6/24/14	Added New Sheet.
DATE	REVISION
STATE OF HAWAII DEPARTMENT OF TRANSPORTATION HIGHWAYS DIVISION	
WATER POLLUTION & EROSION CONTROL NOTES	
HALEAKALA HIGHWAY INTERSECTION IMPROVEMENTS AT KULA HIGHWAY Project No. 37C-01-14	
Date: June, 2014	
SHEET No. 1 OF 3 SHEETS

6/24/14	Added Notes.
DATE	REVISION
STATE OF HAWAII DEPARTMENT OF TRANSPORTATION HIGHWAYS DIVISION	
TYPICAL SECTIONS & DETAILS	
HALEAKALA HIGHWAY INTERSECTION	
IMPROVEMENTS AT KULA HIGHWAY	
Project No. 37C-01-14	
Scale: As Shown	Date: April, 2014
SHEET No. 1 OF 3 SHEETS

DEMOLITION PLAN

**HALEAKALA HIGHWAY INTERSECTION
IMPROVEMENTS AT KULA HIGHWAY**

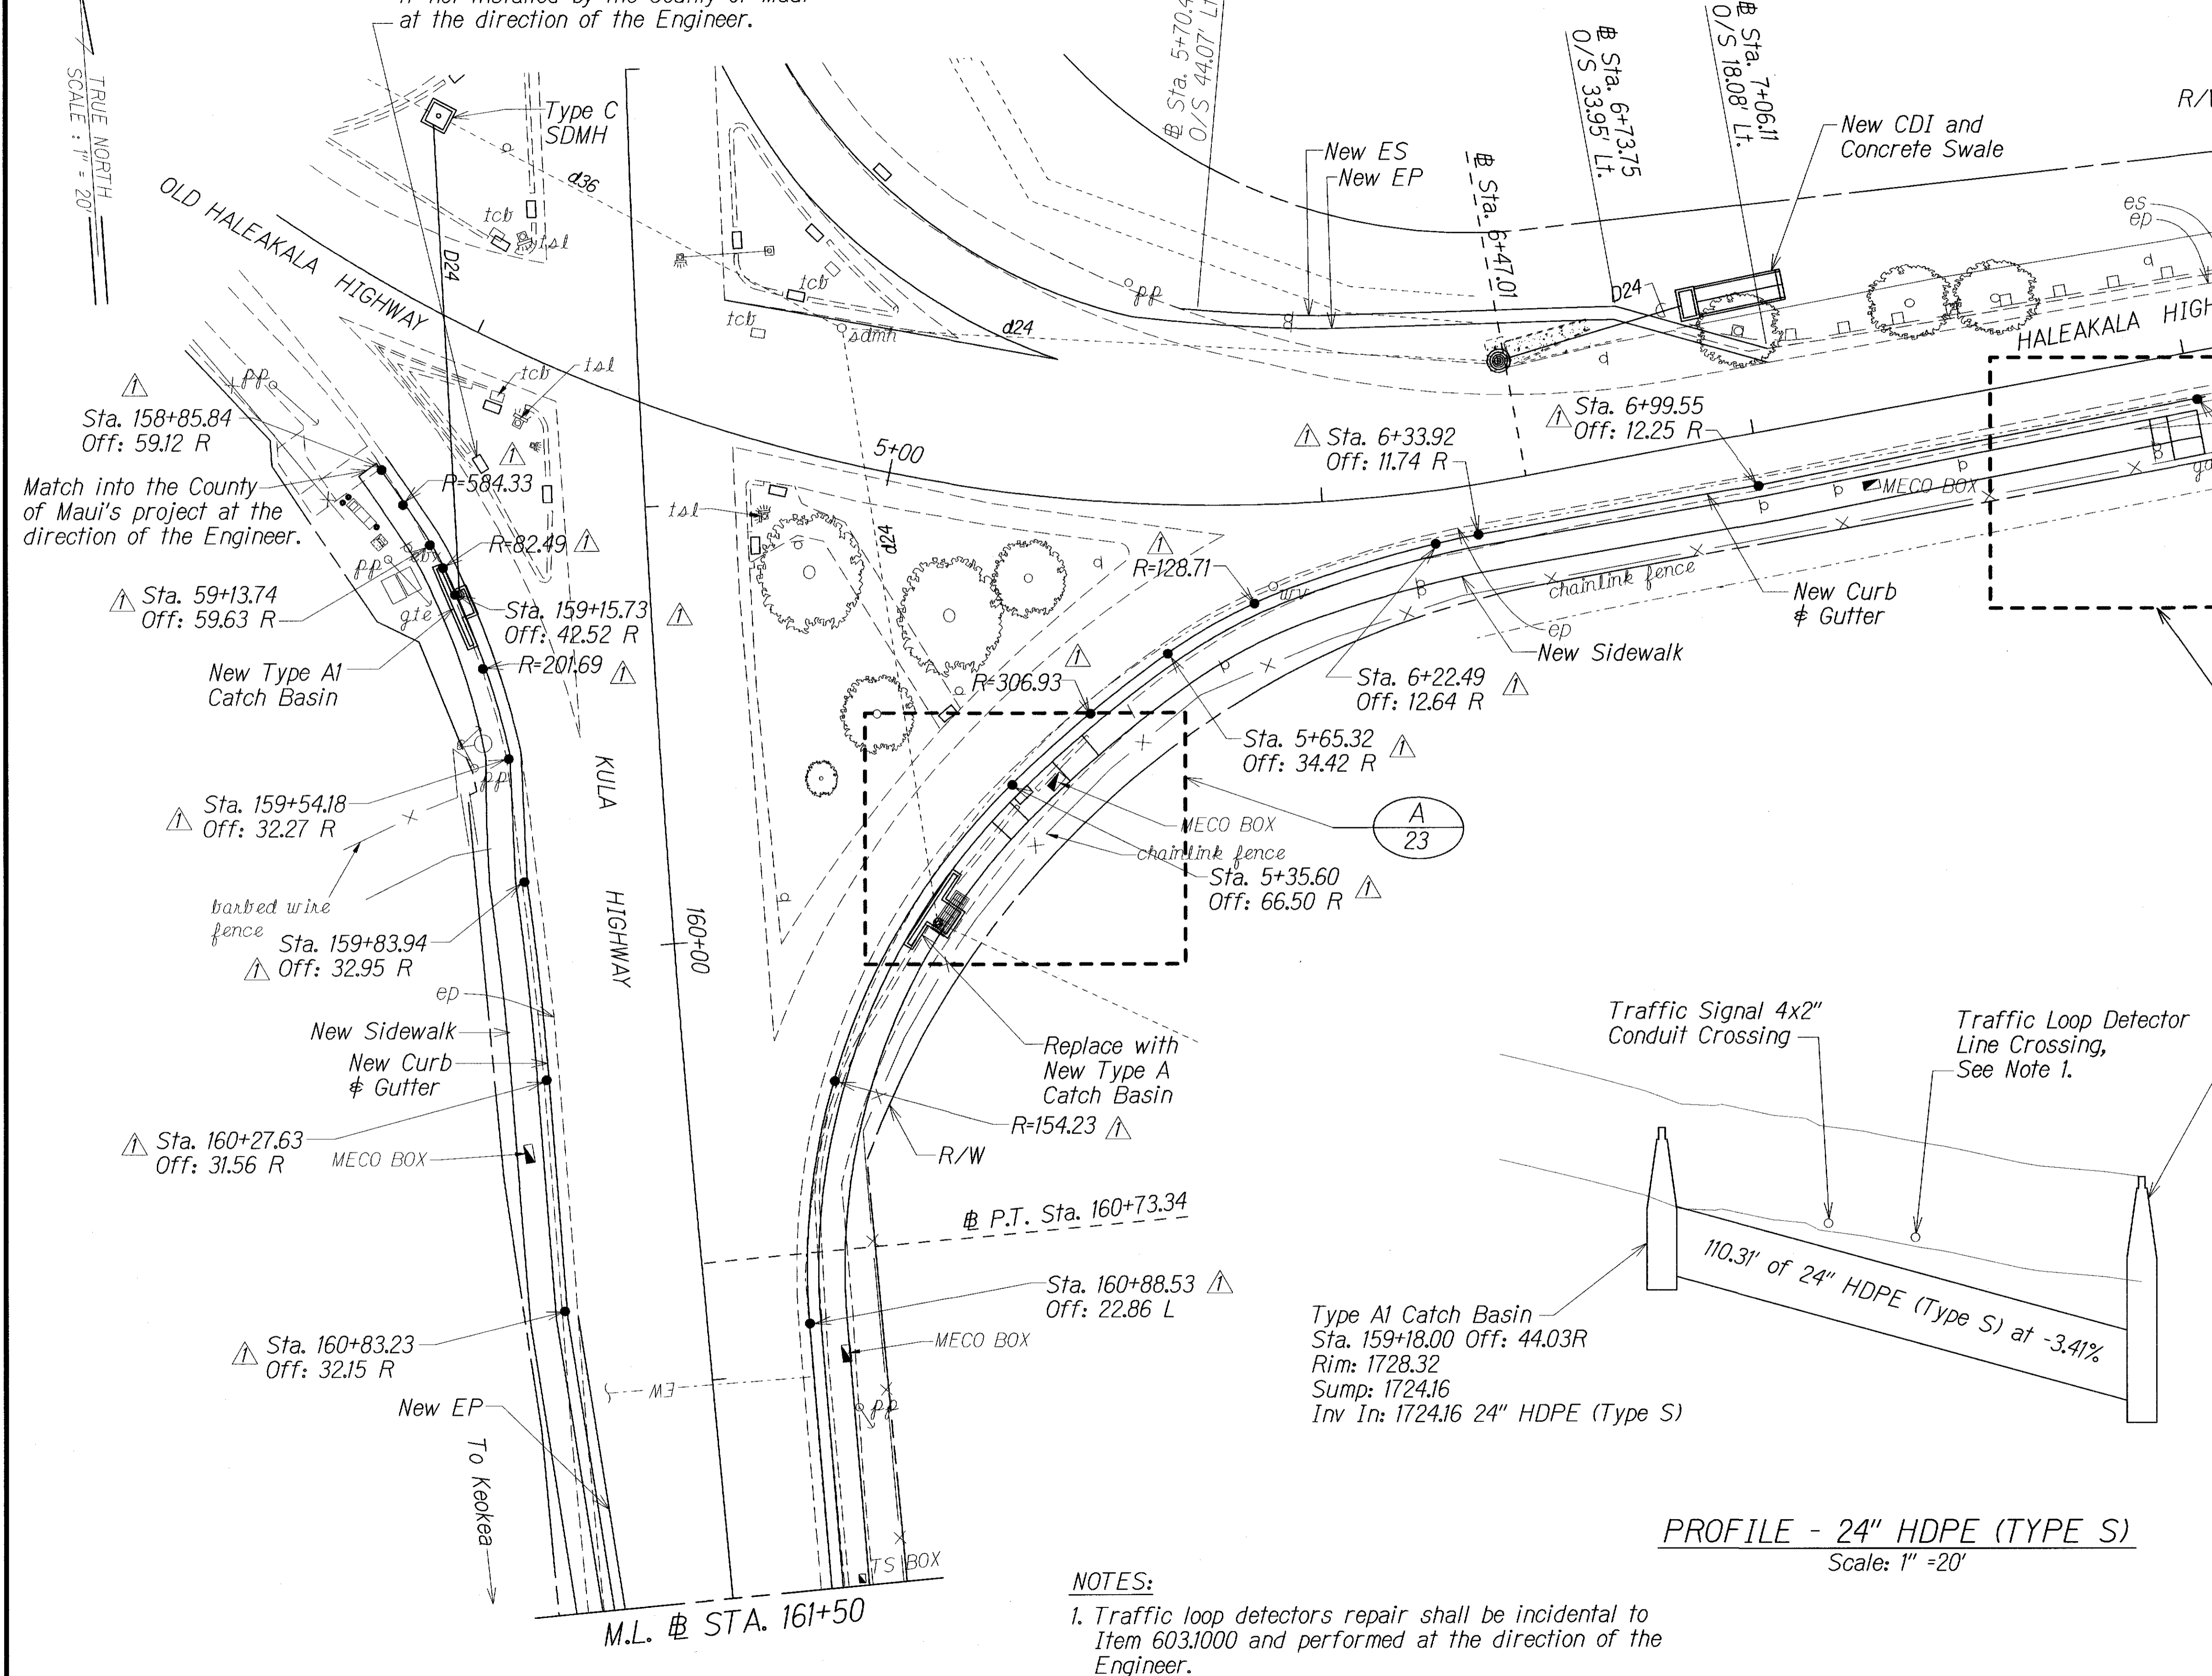
6-25-14 <i>Added Stations, Offsets and Radius on sidewalk.</i>
	DATE _____ REVISION _____
<div style="text-align: center;"> <p>STATE OF HAWAII DEPARTMENT OF TRANSPORTATION HIGHWAYS DIVISION</p> <p><u>SIDEWALK PLAN</u></p> <p><u>HALEAKALA HIGHWAY INTERSECTION</u> <u>IMPROVEMENTS AT KULA HIGHWAY</u> <u>Project No. 37C-01-14</u></p> <p>Scale: 1" = 20' Date: April, 2014</p> <p>SHEET No. 1 OF 3 SHEETS</p> </div>

SIDEWALK PLAN

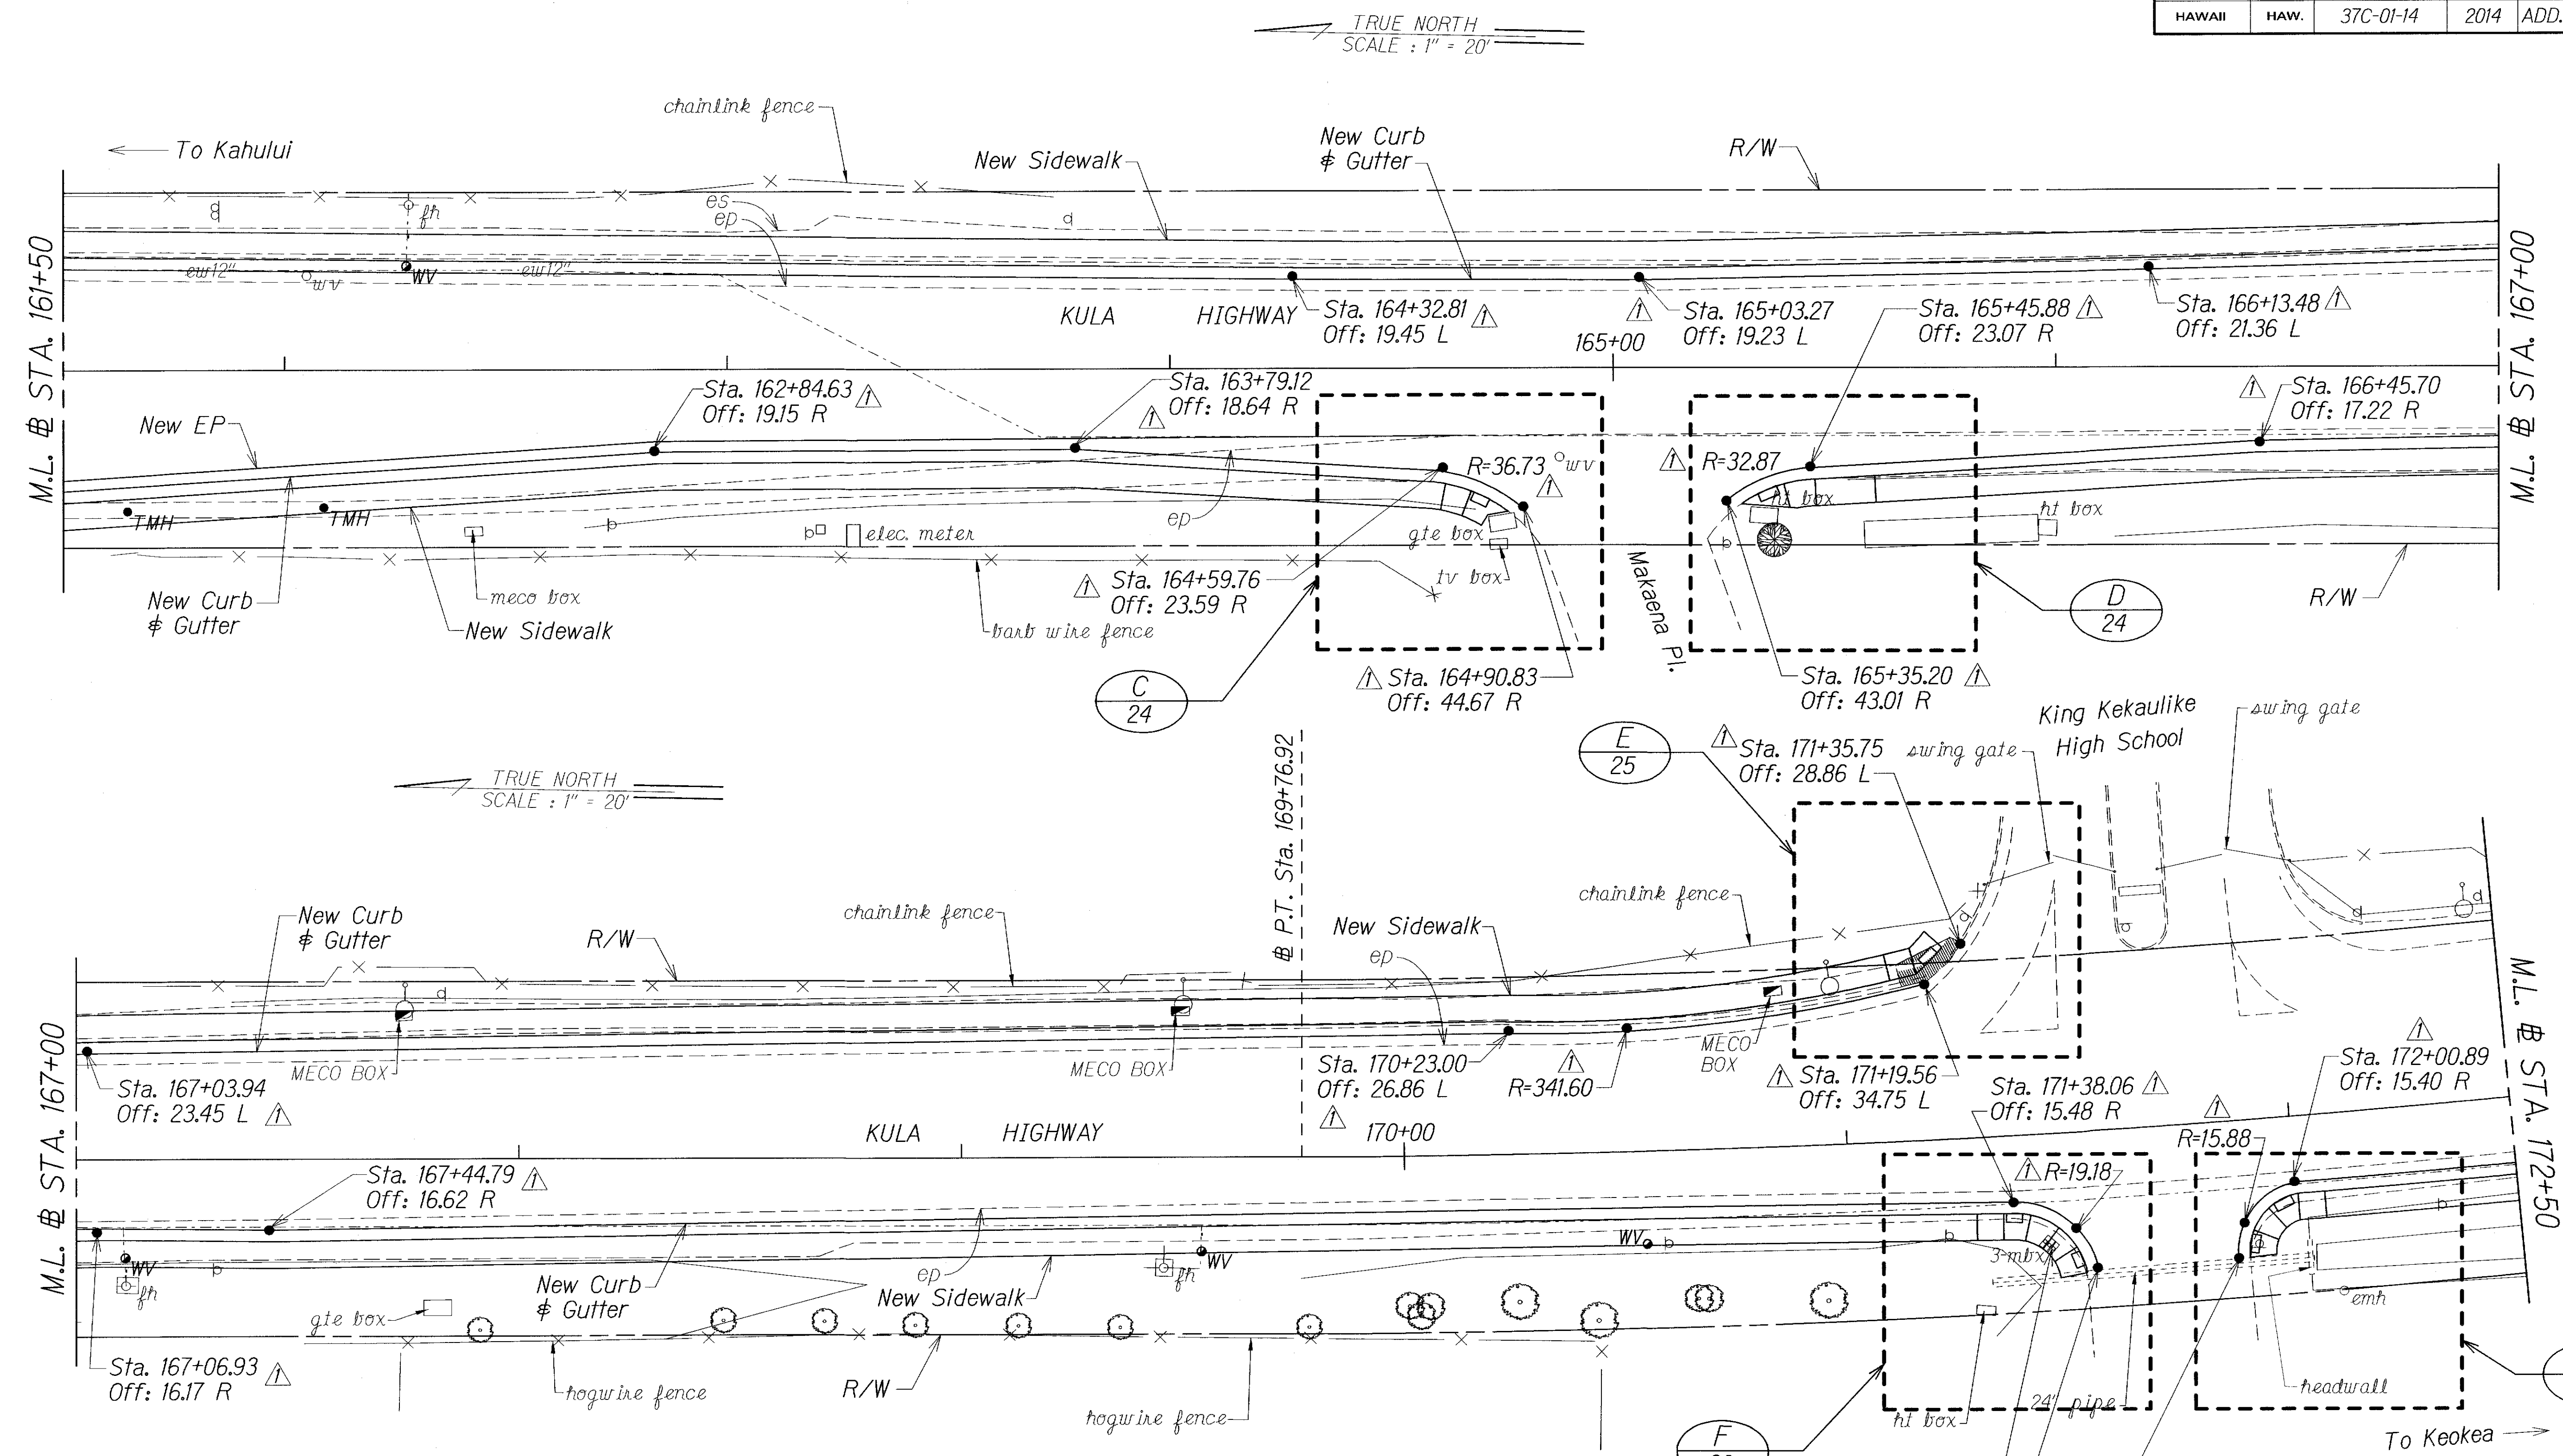
DATE	6-25-14	Added Stations, Offsets and Radius of sidewalk.
DATE		REVISION

STATE OF HAWAII DEPARTMENT OF TRANSPORTATION HIGHWAYS DIVISION
SIDEWALK PLAN
HALEAKALA HIGHWAY INTERSECTION IMPROVEMENTS AT KULA HIGHWAY
Project No. 37C-01-14
Scale: 1" = 20' Date: April, 2014
SHEET No. 3 OF 3 SHEETS

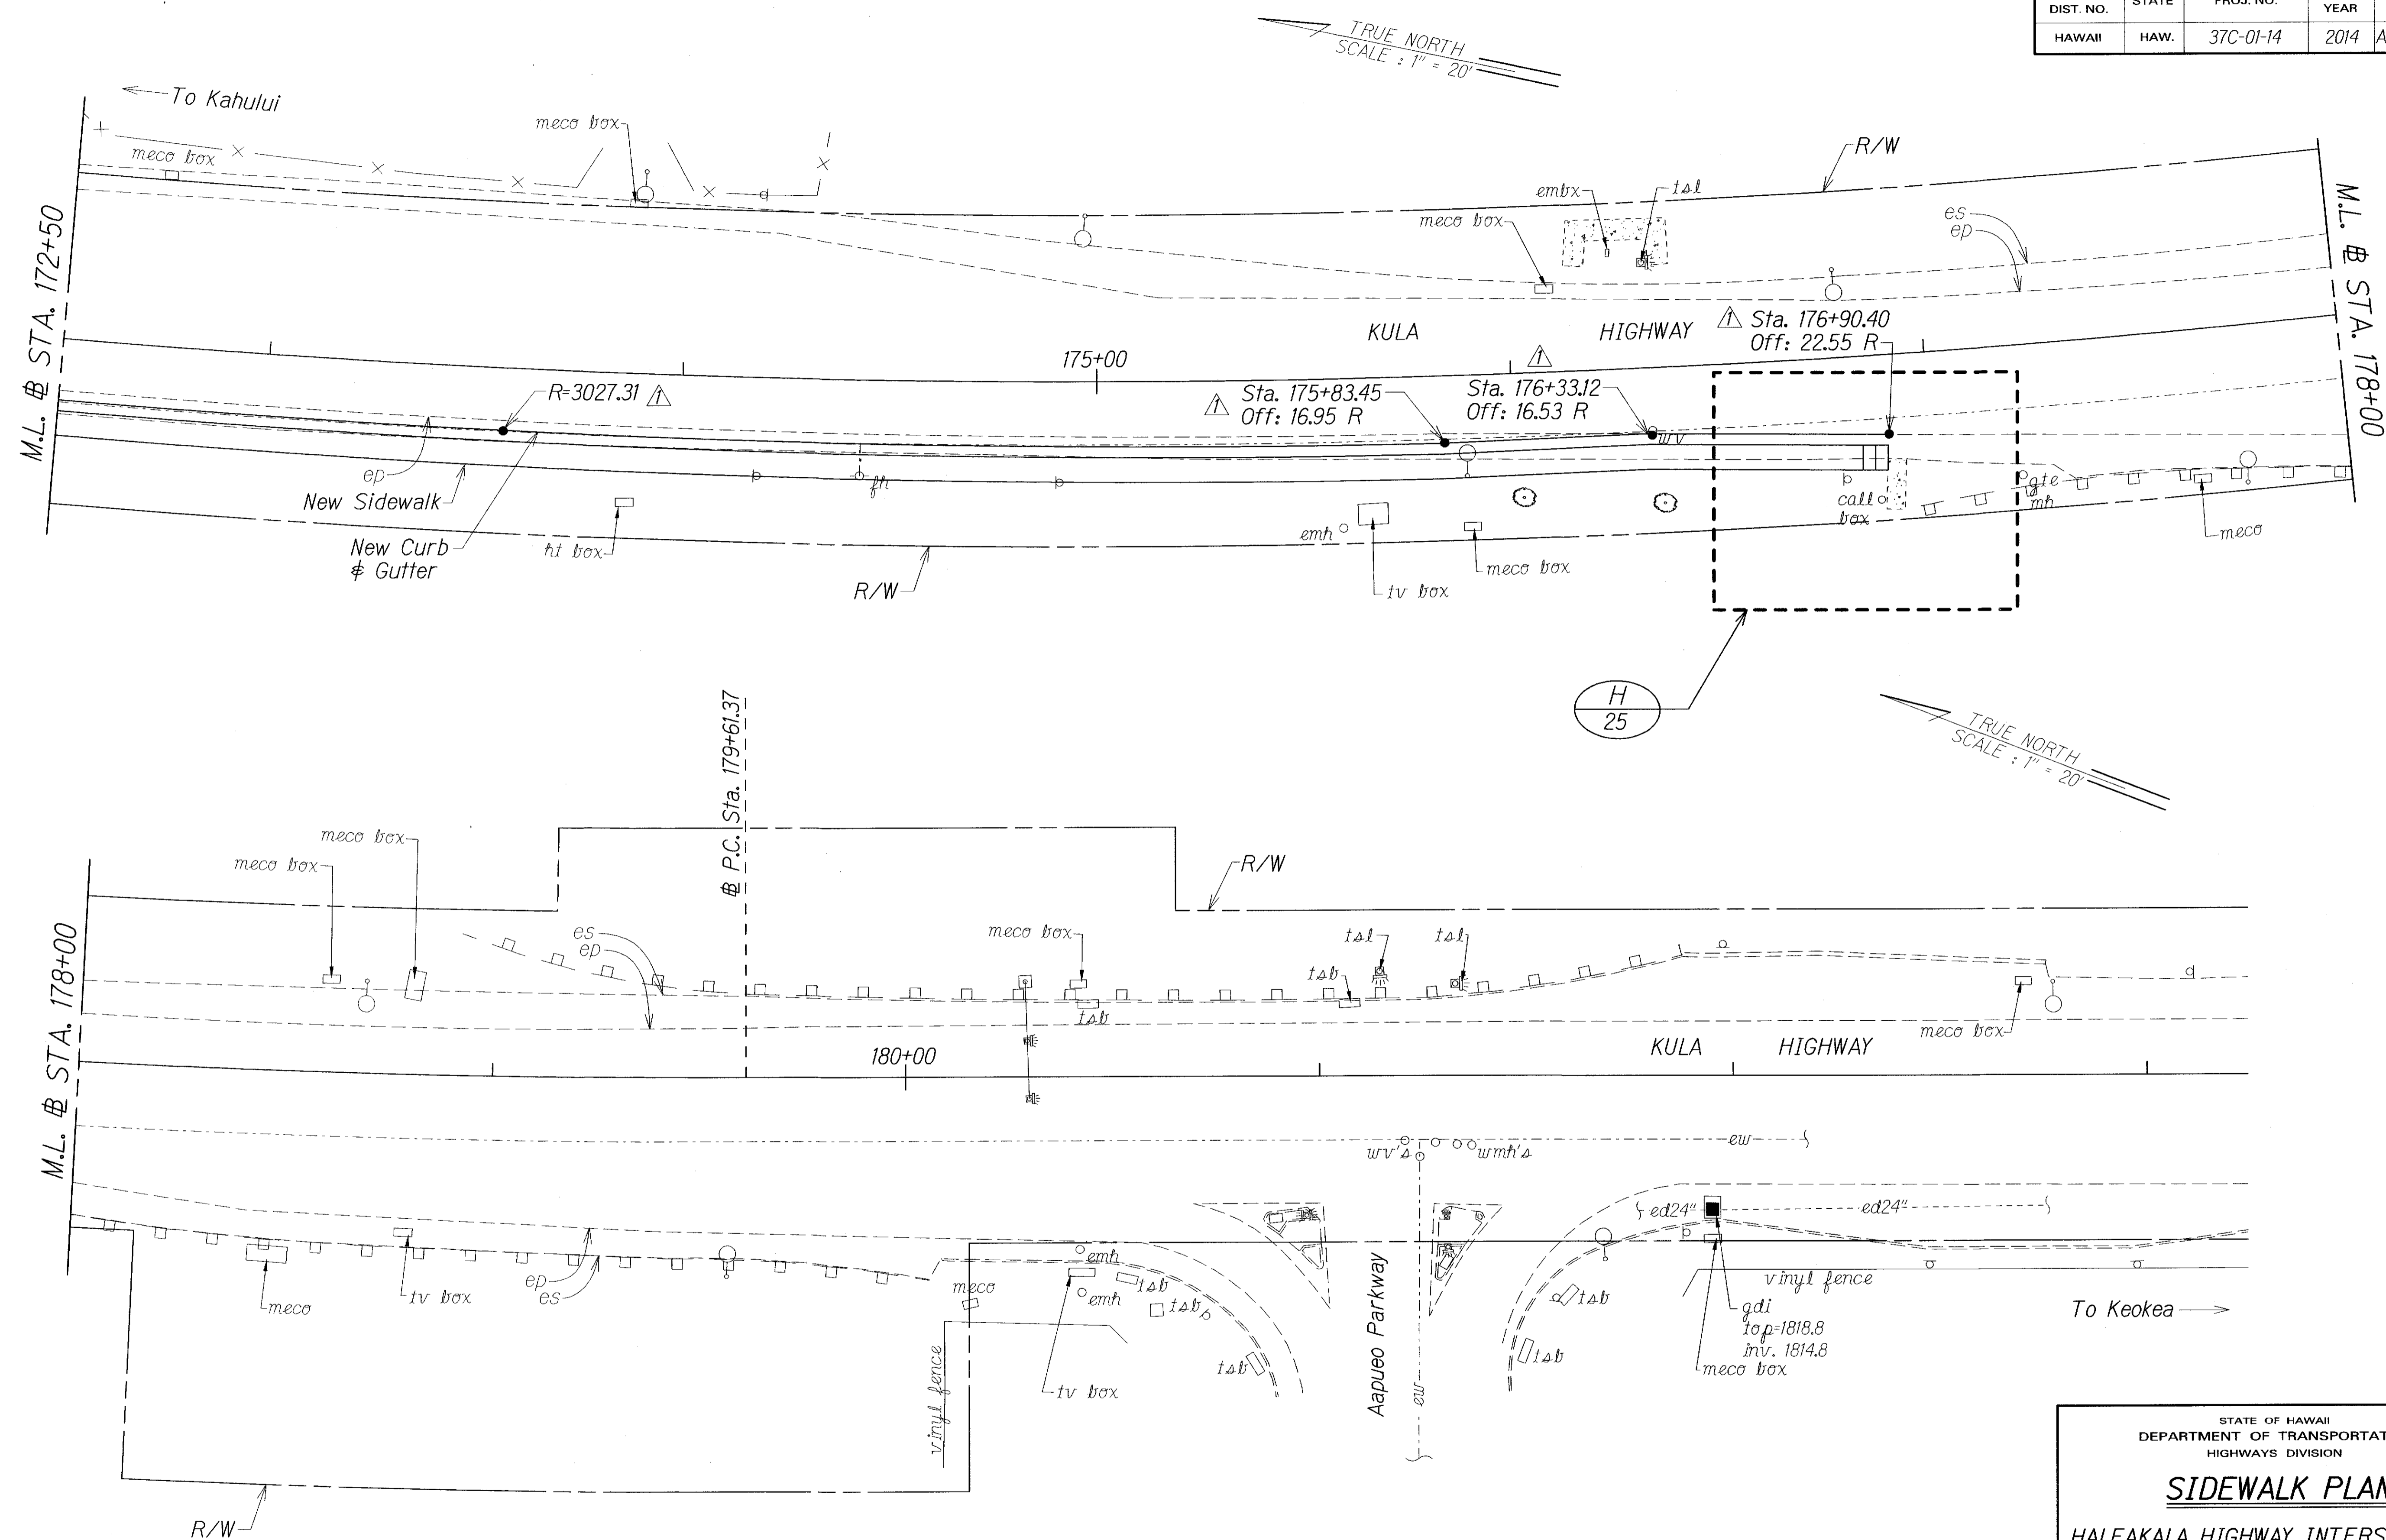
6-25-14	Added Stations, Offsets and Radius on sidewalk.
DATE	REVISION
